Product Change Notice (PCN)

PCN Number: **PCN-0454915-01**

Product(s) Affected: *PJ-096H*

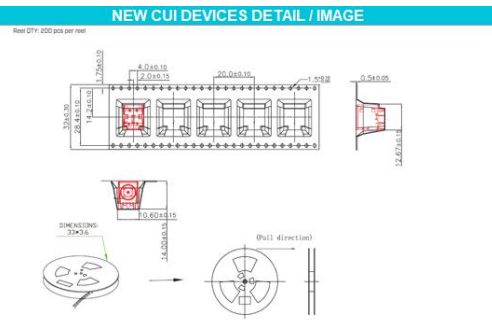
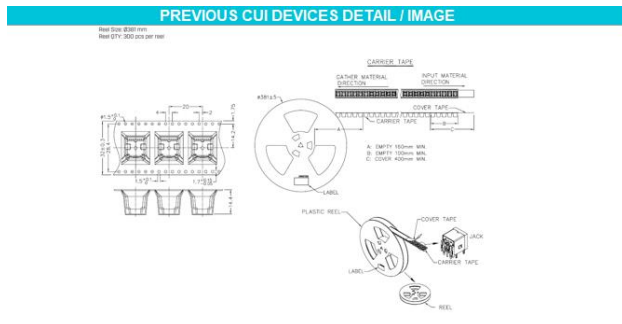
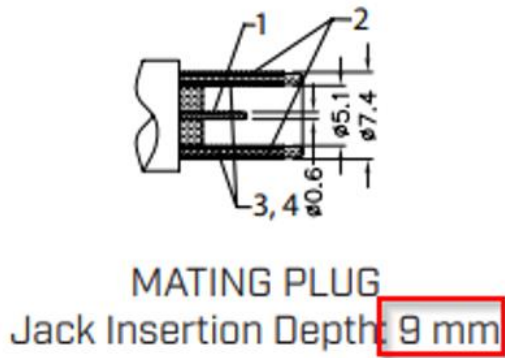
Description of Change: *Minor Housing and footprint differences. Material Change on the housing and terminals. See image Below*

PREVIOUS CUI DEVICES DETAIL / IMAGE			NEW CUI DEVICES DETAIL / IMAGE		
	MATERIAL	PLATING	DESCRIPTION	MATERIAL	PLATING/COLOR
terminal 1	copper alloy	gold flashed	terminal 1	copper alloy t=0.30	gold flash over nickel
terminal 2	copper alloy	gold flashed	terminal 2	copper alloy t=0.30	gold flash over nickel
terminal 3	copper alloy	gold flashed	terminal 3	copper alloy t=0.30	gold flash over nickel
terminal 4	copper alloy	gold flashed	terminal 4	copper alloy t=0.30	gold flash over nickel
spring	stainless steel		shield	brass t=0.35	nickel
shield	brass	nickel	insulator	LCP (UL94V-0)	black
insulator	PA10T
